STAFF PAPER

Review of Modesto Irrigation District 2019 Integrated Resource Plan Filing

June 2019 | CEC-200-2019-008

Figure 1: Modesto and Energy Commission Energy Forecasts 2018-2030 (GWh)

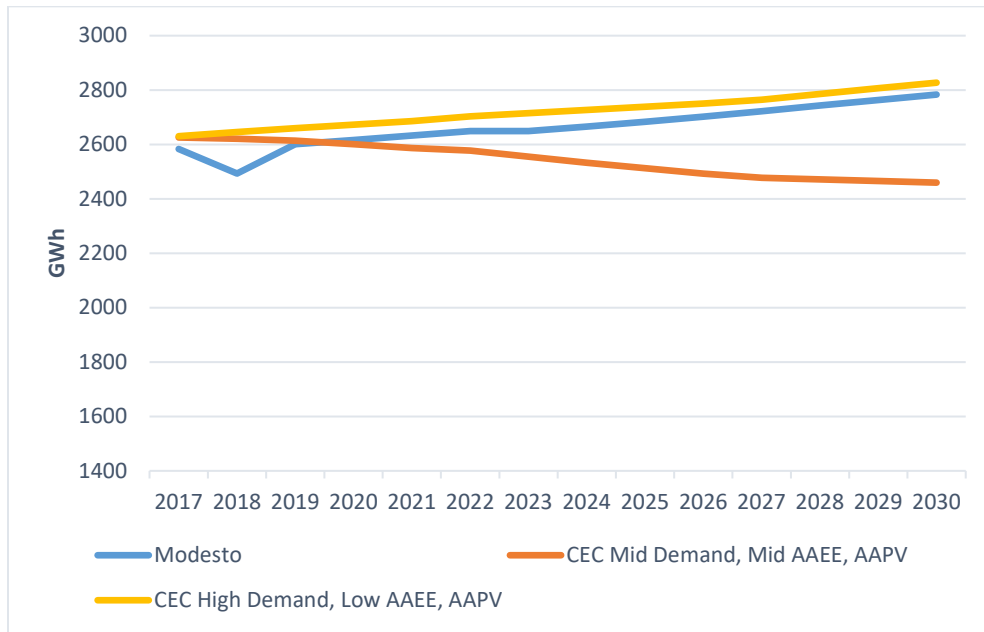
Modesto's net energy demand forecast shows an annual growth of 0.9 percent from 2018 to 2030. The annual energy growth rate was -0.2 percent from 2008 to 2017. The energy forecast growth is mostly due to the regional economic recovery after 2014. The Modesto forecast is comparable to the Energy Commission's forecast, falling within the range of the mid demand case and the high demand case, as shown in **Figure 1**.⁶

Figure 2: Modesto and Energy Commission Peak Forecasts 2018–2030 (MW)

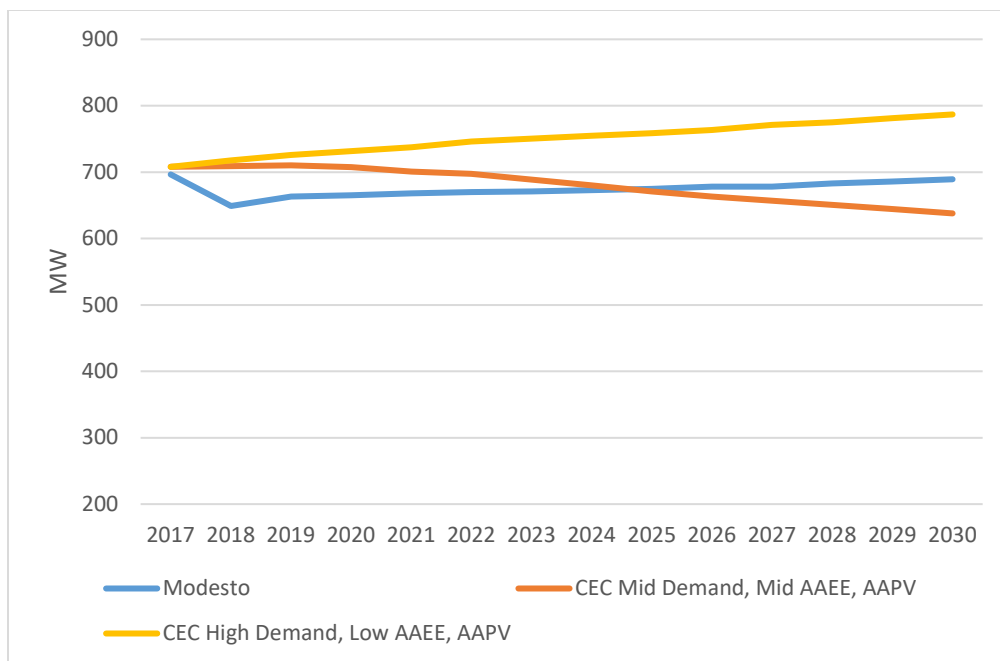
The Modesto peak demand forecast has an annual growth of 0.4 percent from 2018 to 2030. The annual peak demand growth from 2008 to 2017 was low at 0.8 percent, largely because of slower annual growth in demographic variables. The peak forecast is in the range of Energy Commission’s mid demand and high demand cases, as shown in Figure 2.

The differences between Modesto's and the Energy Commission's forecasts could be because of differences in modeling methods, since the Energy Commission's forecasts uses an end-use forecast, and Modesto uses an econometric forecast. Another potential source of the difference between Modesto and the Energy Commission forecast could be how additional achievable energy efficiency (AAEE) and additional achievable solar photovoltaic are calculated and incorporated into the models.
